City of Portland, Oregon
Bureau of Development Services
Land Use Services
FROM CONCEPT TO CONSTRUCTION

**NOTICE OF A TYPE II DECISION ON A PROPOSAL IN
YOUR NEIGHBORHOOD**

CASE FILE NUMBER: LU 22-200375 AD

Proposal:

SITE PLAN

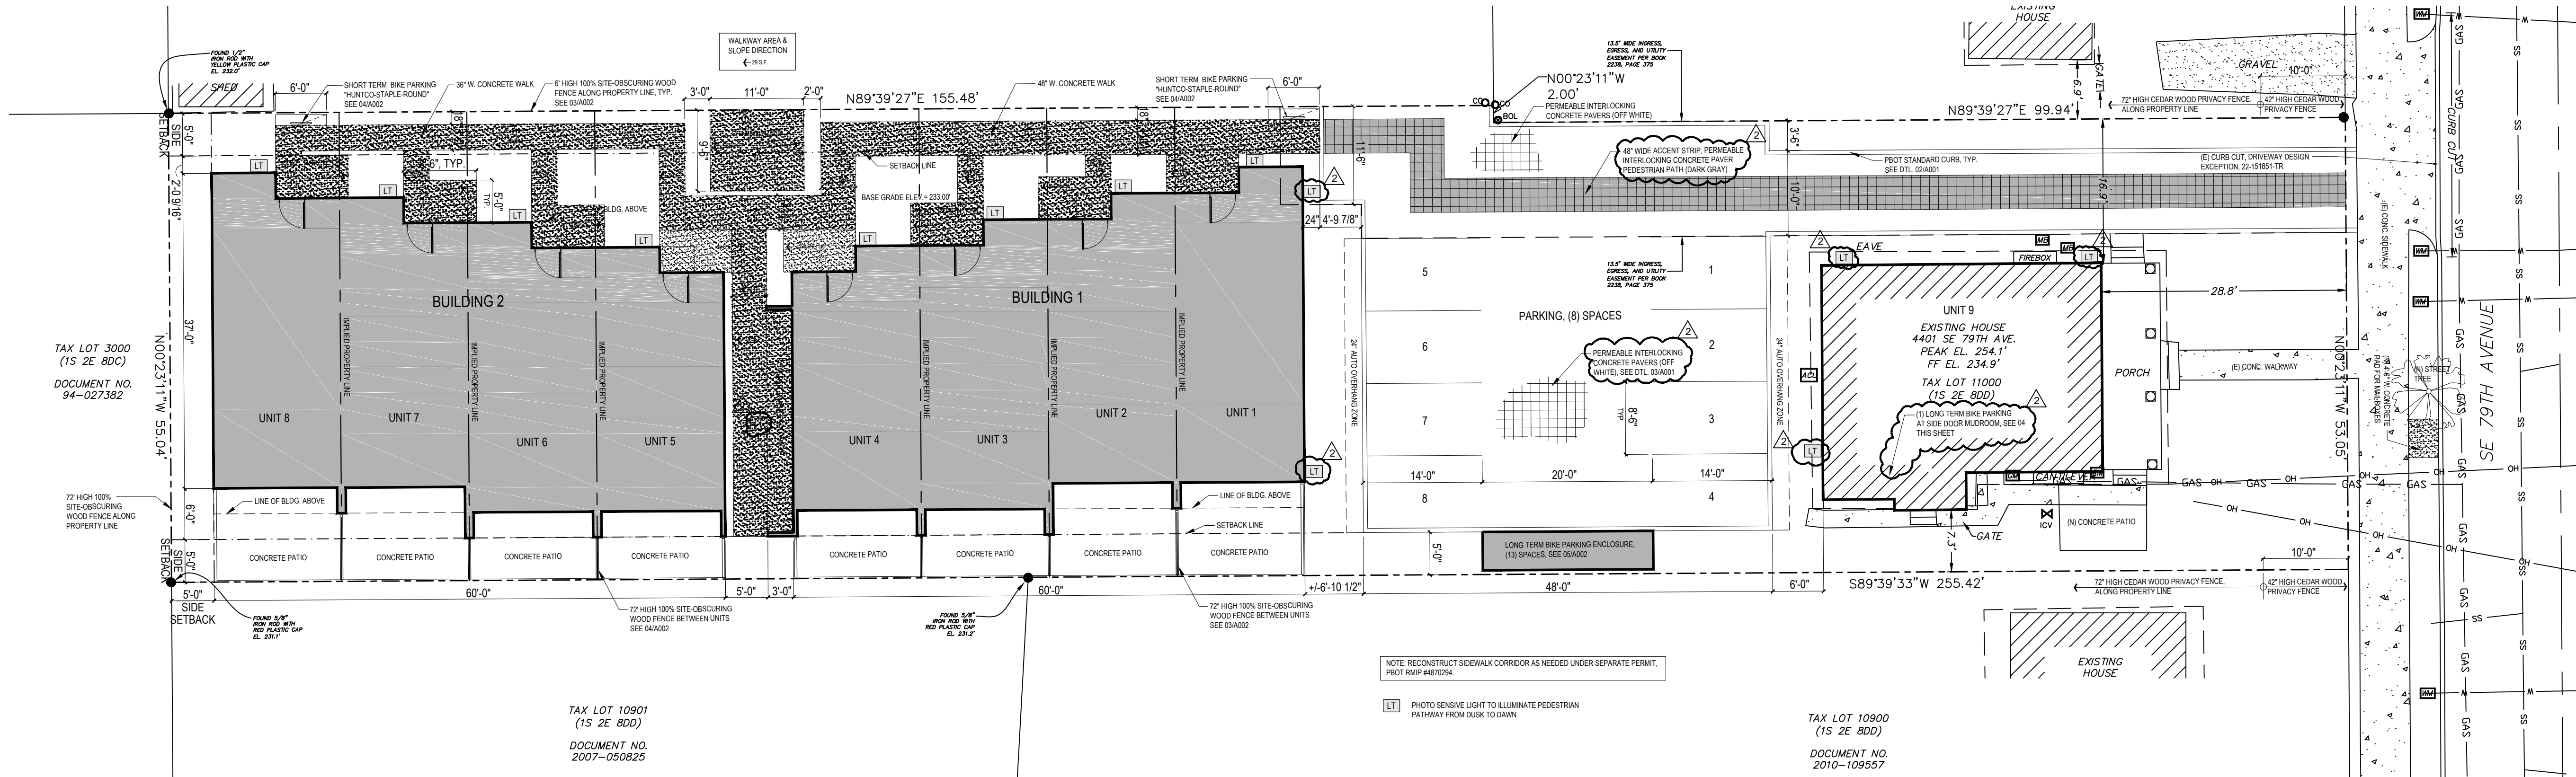
1. **Fence.** The narrative indicates a cedar fence will be constructed along the north property line. Posts and boards for such a fence generally reduce the width of a landscape area by 6 inches. No fence is shown on the landscape plan. Does the proposed 3'6" landscape area accommodate the 6" for the fence? How tall is the proposed fence? Do you have the design for it yet?

RESPONSE: Plans, attached, have been updated to display notation - located at the NE and SE corners of the Site Plan - calling out fence specifications for a 6' tall horizontal cedar fence along the North property line, reduced to 3.5' tall in the front setback. Attached please also find a sample picture of the backyard fence in a previous UrbanRoost project, Montavilla Courtyard, which precisely reflects the design and construction standards to which the proposed fence will be built. The proposed landscaped area will remain unchanged as there is already room drawn to accommodate the 6" fence posts and boards. Plans show the 3'6" wide setback along the North side; 3' of this area will be landscaped after 6 inches are given to fencing width.

01 Landscape Plan Scale: 3/32"=1'-0" N

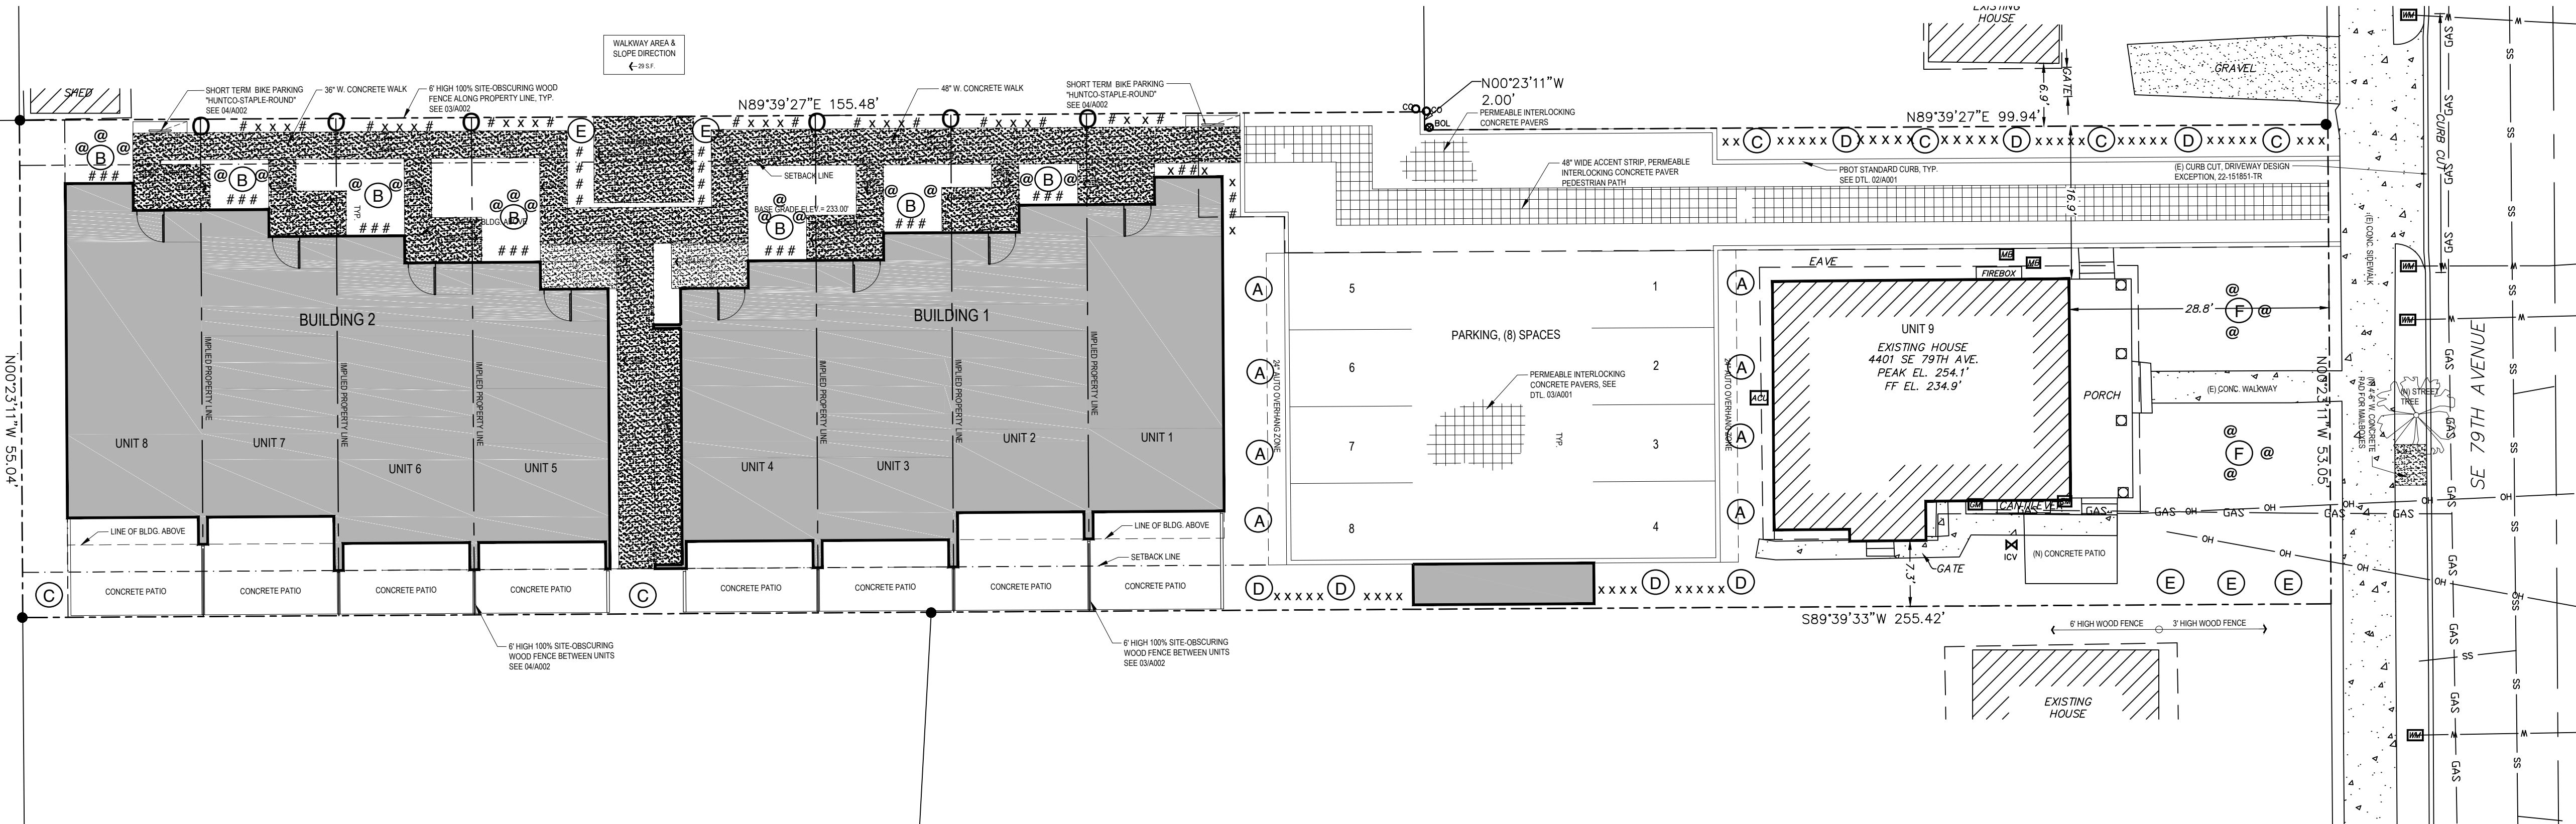
a. Mitigation. The narrative states, "As a mitigating measure, the applicant proposes to increase the required L3 landscaping requirements to 150% of the required plantings." Please explain what this means, and where these additional plants will be located.

b. Provided landscaping. It does not appear that the landscape plan currently meets the L3 standard in the reduced setback area along the north property line with only 6 low-screen shrubs instead of a continuous screen of high- screen shrubs. The same is true on the south end of the parking lot as well.

RESPONSE: Apologies for the lack of clarity; the applicant's phrase "As a mitigating measure, the applicant proposes to increase the required L3 landscaping requirements to 150% of the required plantings" should have been clearer. The comment was intended to describe the required tree plantings. The Required Materials in the L3 code section states "one large tree is required per 30 linear feet of landscaped area, one medium tree per 22 linear feet of landscaped area, or one small tree per 15 linear feet of landscaped area." The landscaped area

As regards shrubs, the applicant proposes the use of Ilex Crenata 'Sky Pencil' ('Sky Sentry') Japanese Holly which is described in the Portland Tree and Landscaping Manual as an evergreen shrub that grows to 8 feet tall, to be planted 1.5' apart on center. These will be added to the site plan at the appropriate spacing/density in lieu of the current shrubs if satisfactory to the adjustment reviewer.

SUBMITTED 12/22/22
LU 22-200375 AD, Exhibit C.1

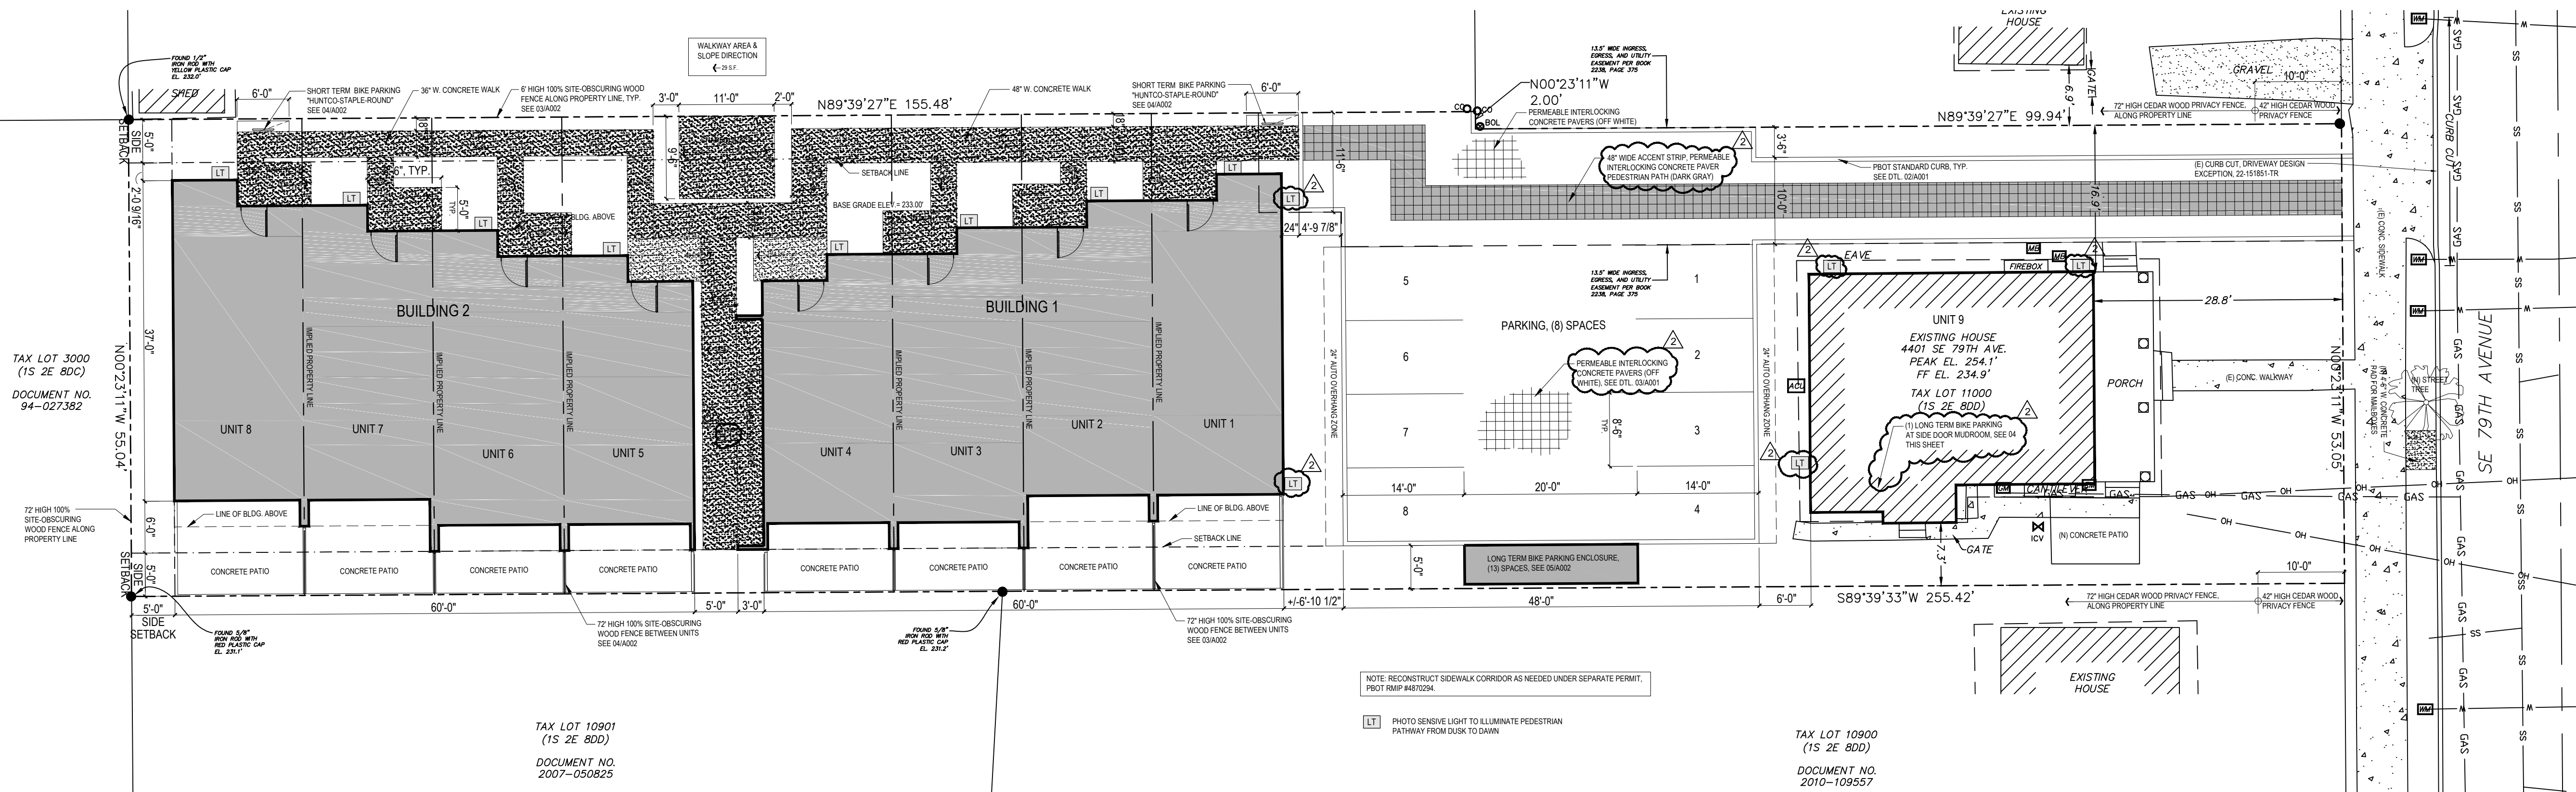
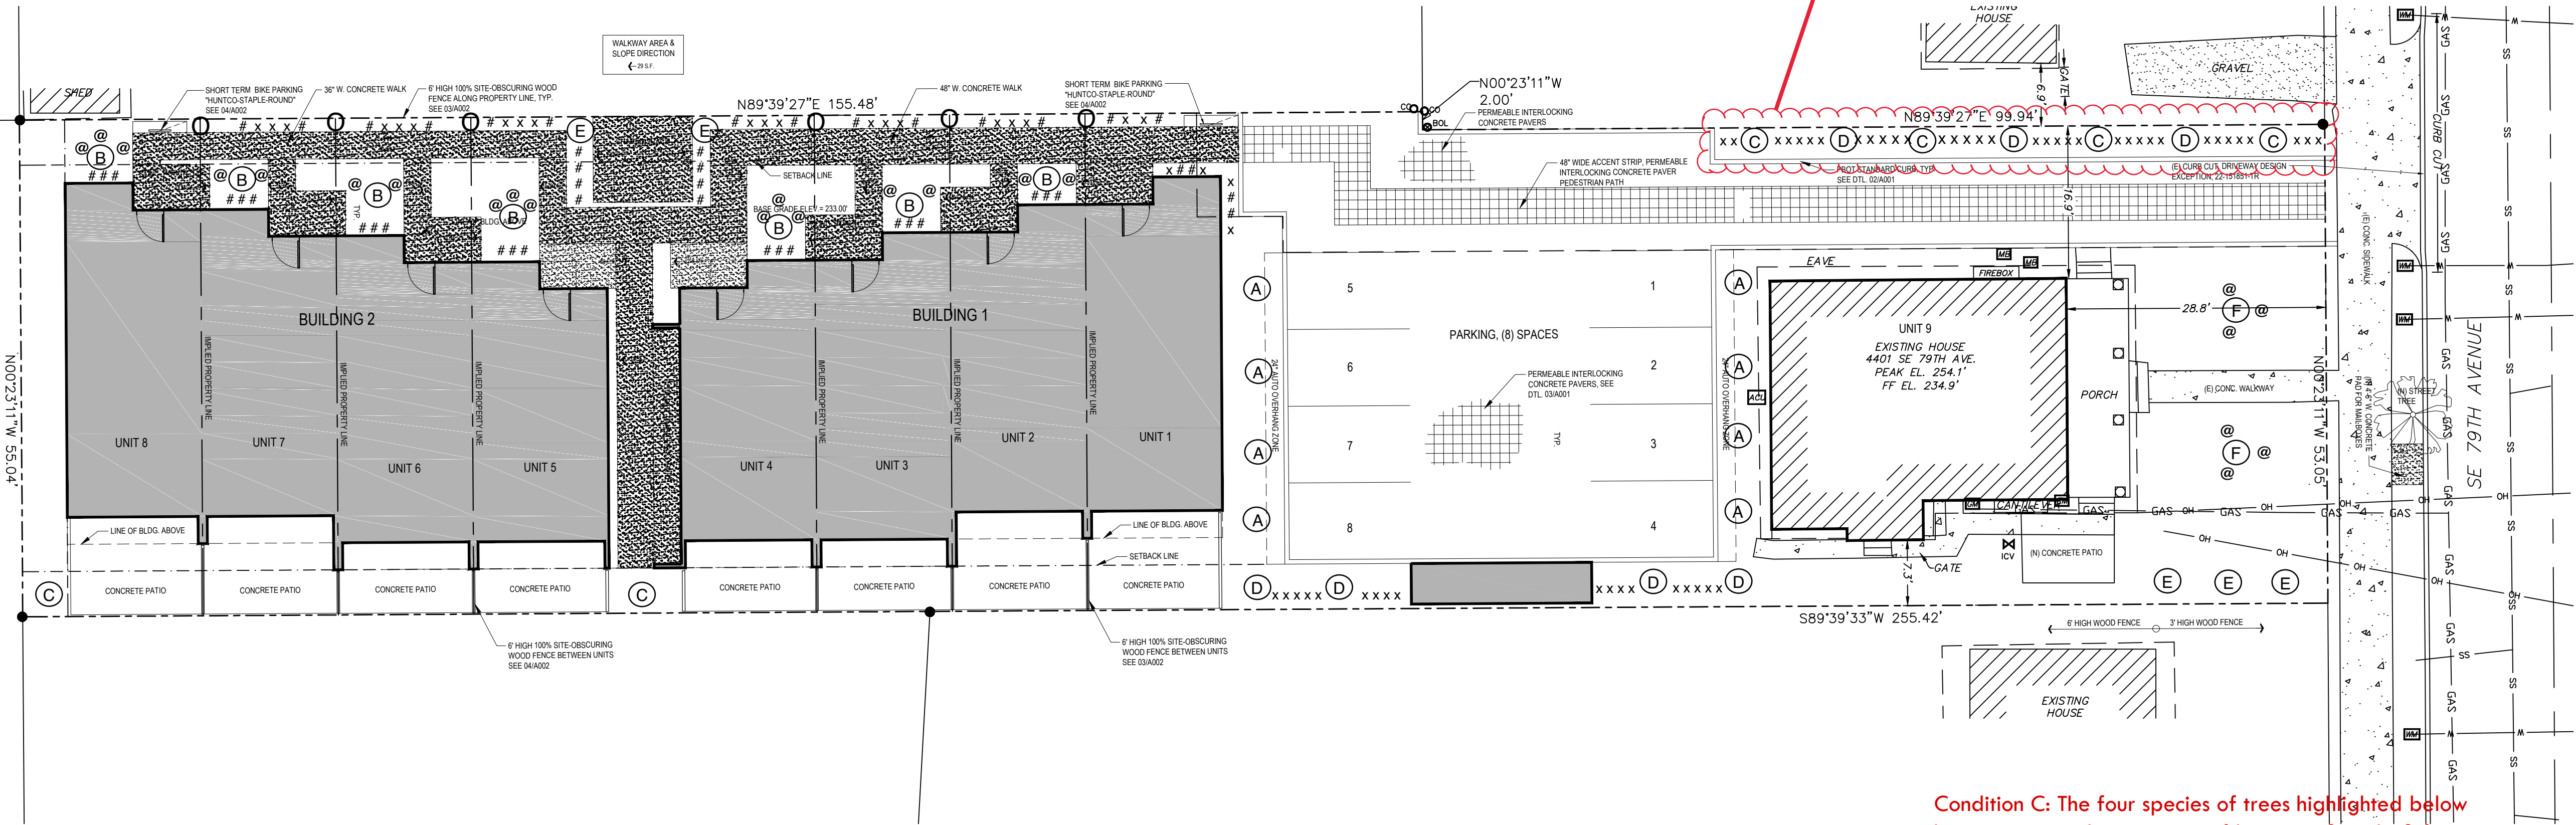
Staff finds that, with a new wooden fence along the north property line, and with conditions requiring the L3 standard to be met in the 67-foot-long, reduced-width landscape area north of the driveway; as well as a condition requiring the planting of some of the proposed trees taller than what is required by code, the proposed Adjustment is consistent with the purpose of the requirement to be modified and with the character intended for the area. With the described conditions, staff finds the approval criteria for the Adjustment are met. Since the approval criteria are met, the Adjustment request must be approved.

- B. The landscaping in the reduced setback area north of the proposed driveway must meet the L3 standard for shrubs and ground cover (the tree standard is exceeded as proposed).
- C. Per the landscaping plan of Exhibit C.2, the applicant must plant the following species and number of trees at the minimum heights indicated:
- 8 Himalayan White Birches will be a minimum of 10 feet tall;
 - 6 Goldspire Ginkgos will be at least 8 feet tall;
 - 5 Italian Cypress will be at least 8 feet tall; and
 - 2 Jefferson Maples will be at least 10 feet tall.

- C. Per the landscaping plan of Exhibit C.2, the applicant must plant the following species and number of trees at the minimum heights indicated:
- 8 Himalayan White Birches will be a minimum of 10 feet tall;
